4328 Brooklyn Ave NE

Recommendation Meeting

SDCI: 3036008-LU

February 28, 2022

Appendix: Priorities & Board Recommendations -Massing & Materials

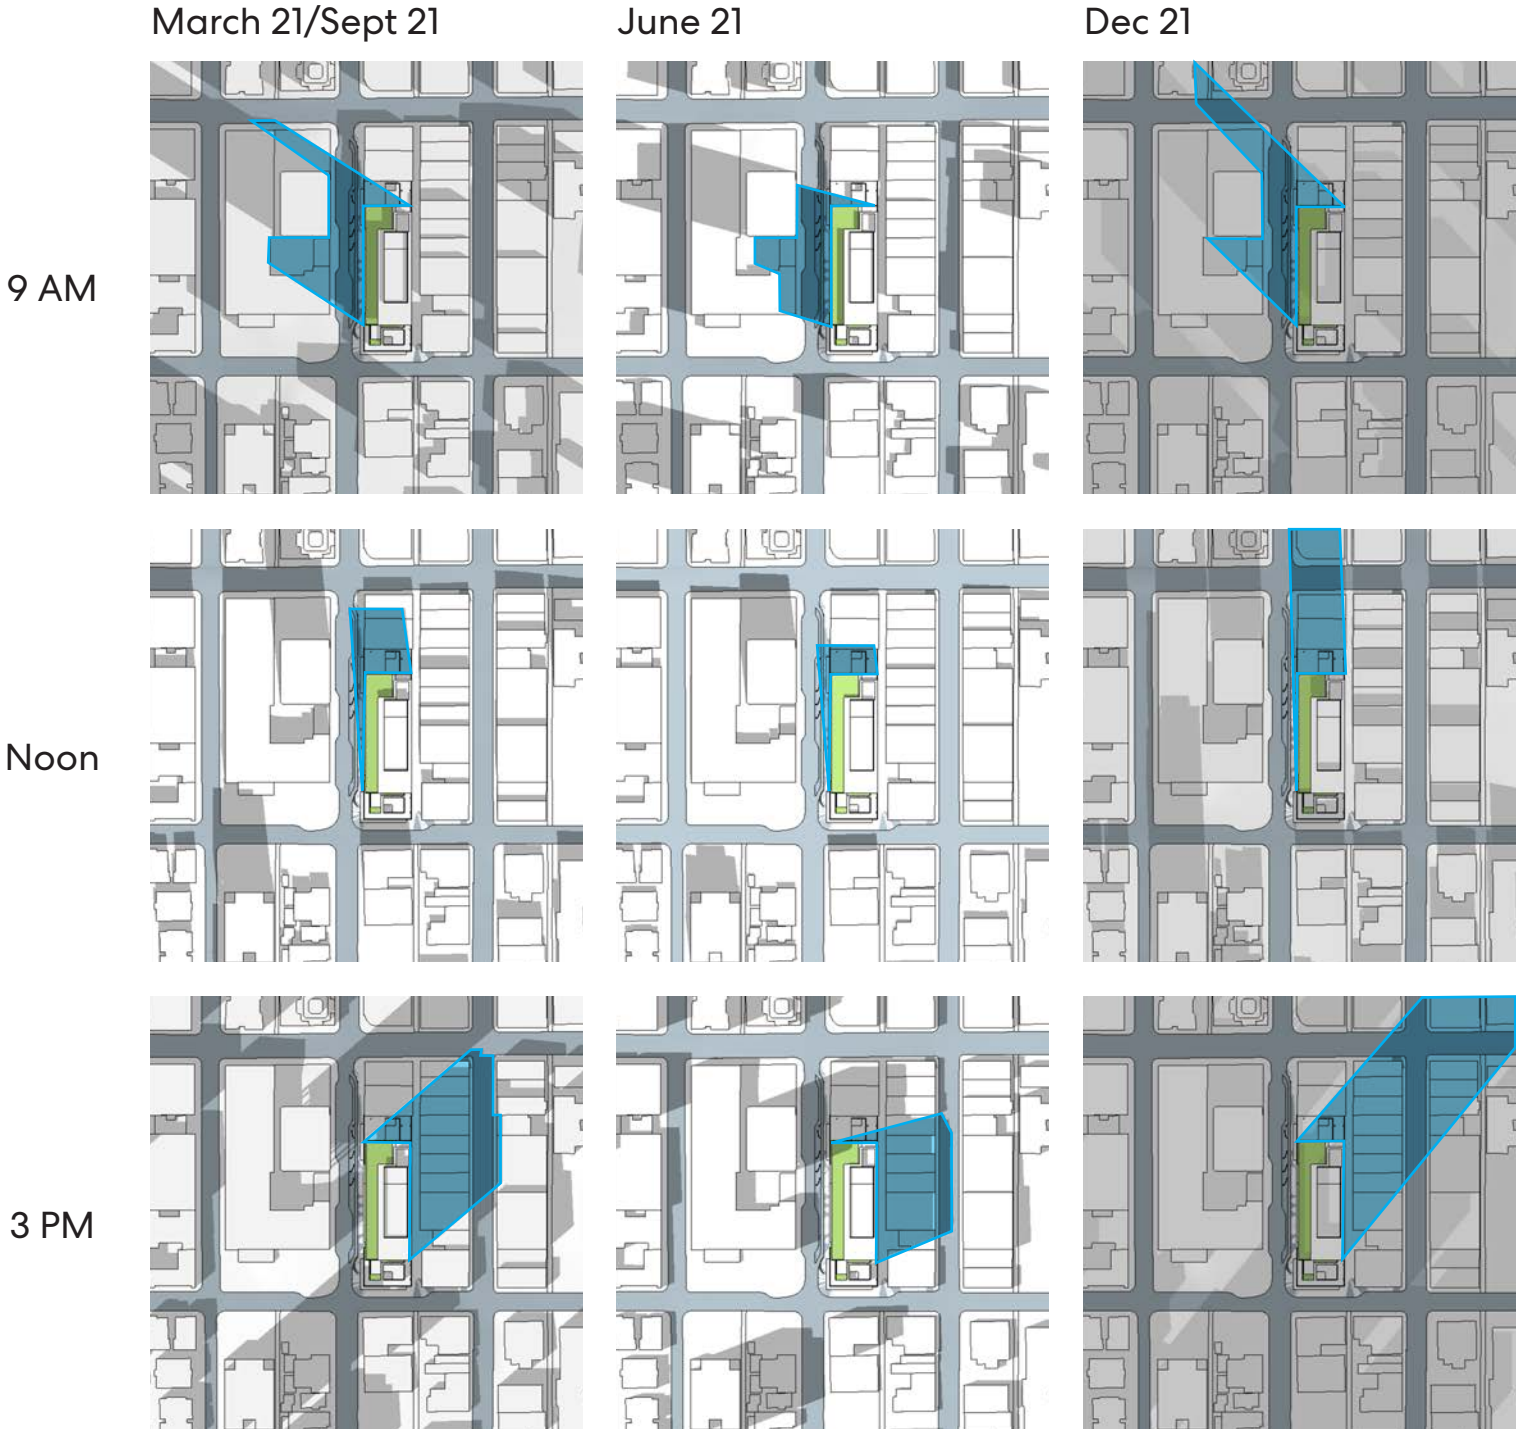
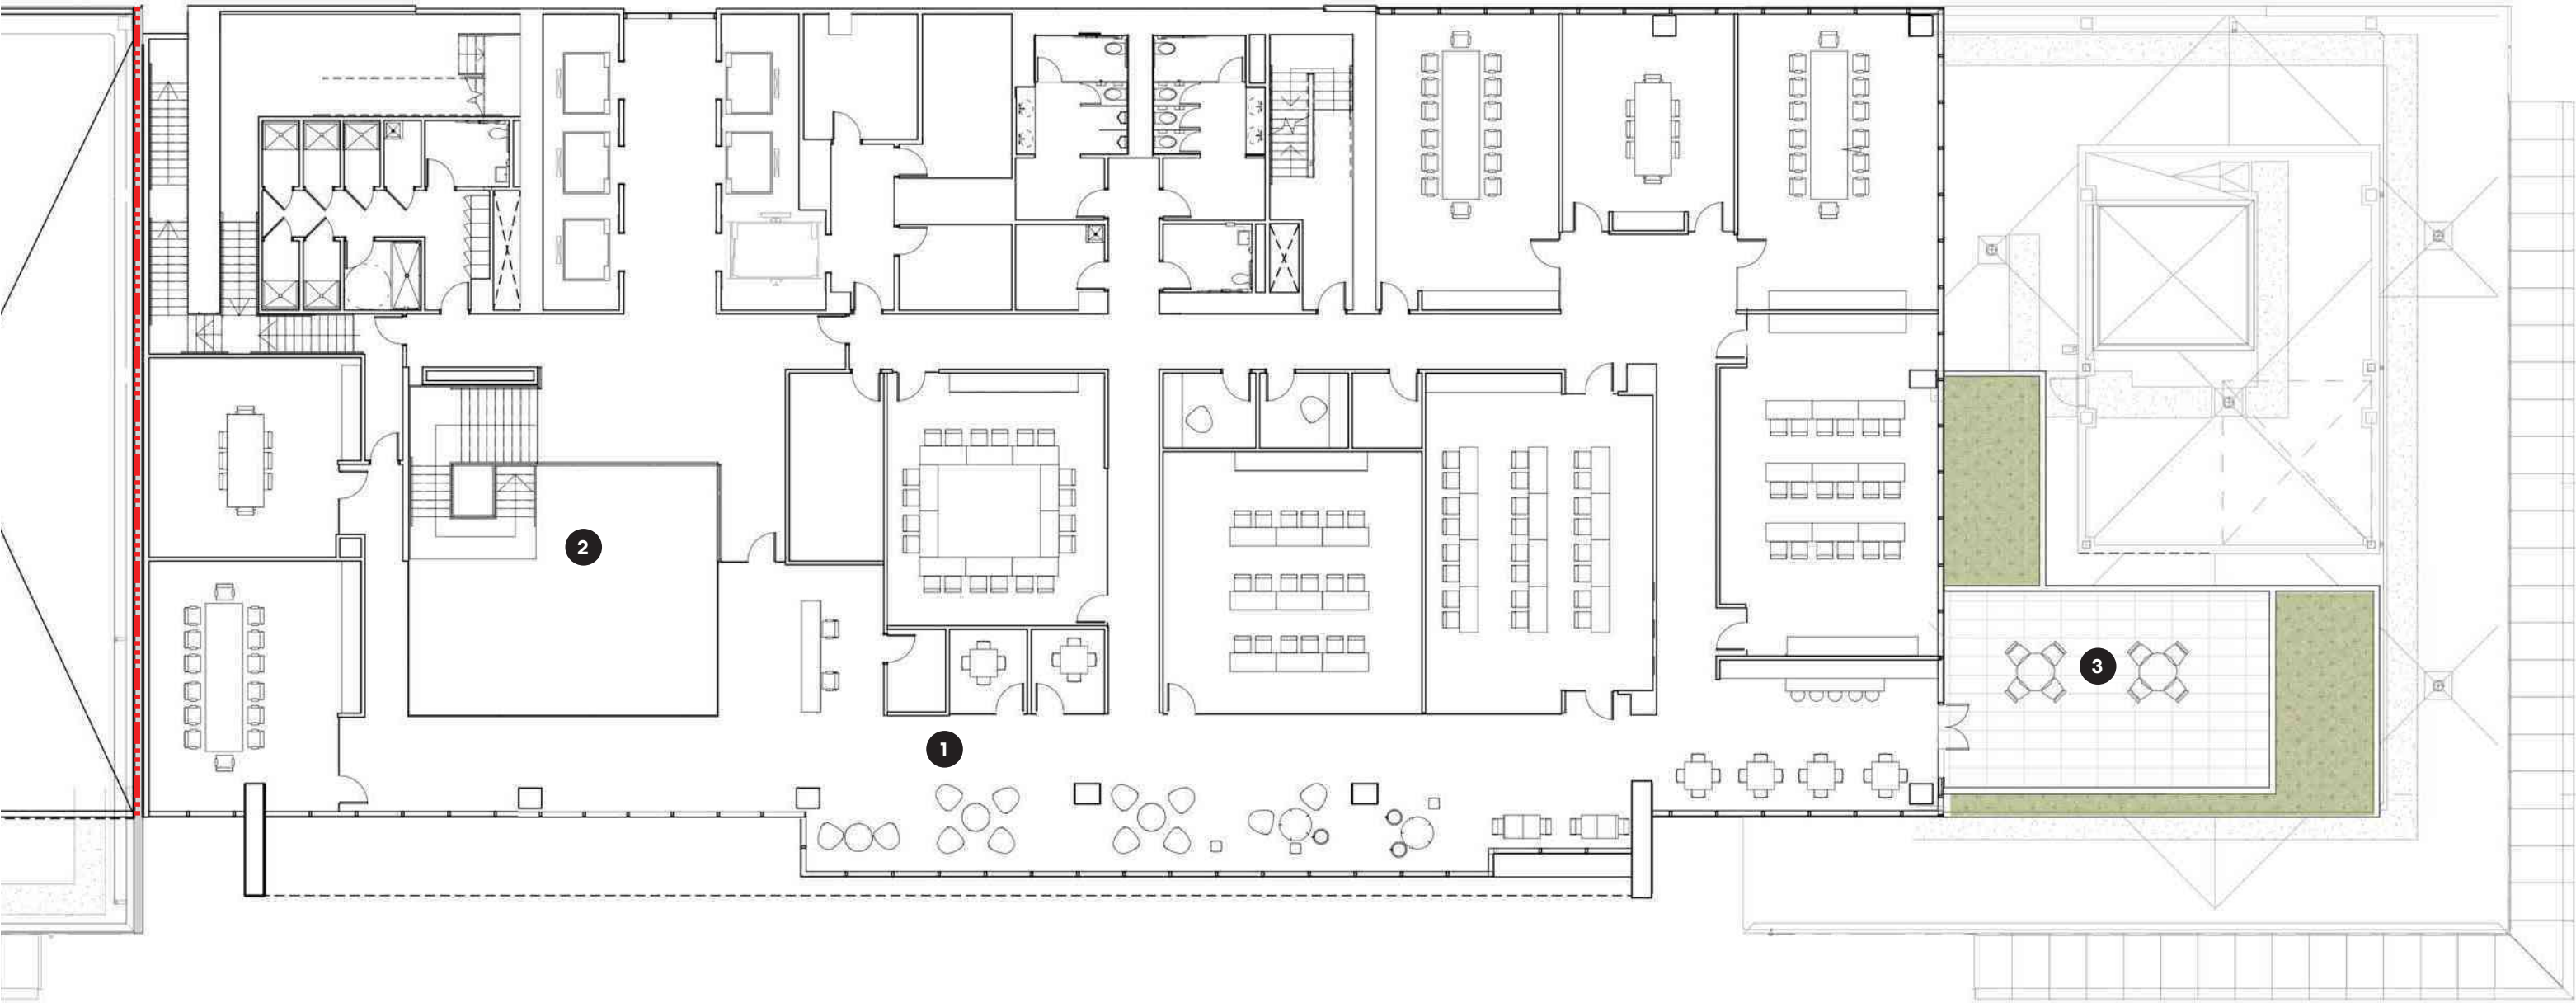
- 1a) *The simple massing with large inset responded to the surrounding context and marked the building's features well*
- the shape is simple and elegant but requires high-quality materials and thoughtful detailing for the skin to “sing”*
 - explore innovation in the use of materials*
 - the massing responds well to the complexities of the site, given the two transit station entries*

1. The podium frame and tower aperture relate to the rhythms and proportions established by the transit stations creating an overall massing response and architectural expression that is cohesive, unified, and uniquely site sensitive
(CS2-A.1, CS2-A.2, DC2-1a, DC2-B.1, DC2-2a)
2. The lantern like tower volume is lifted above the nested podium creating a visual sense of compositional lightness
(CS2-A.1, CS2-A.2, CS2-B.2, DC2-B.1, DC2-2a, DC2-2c)
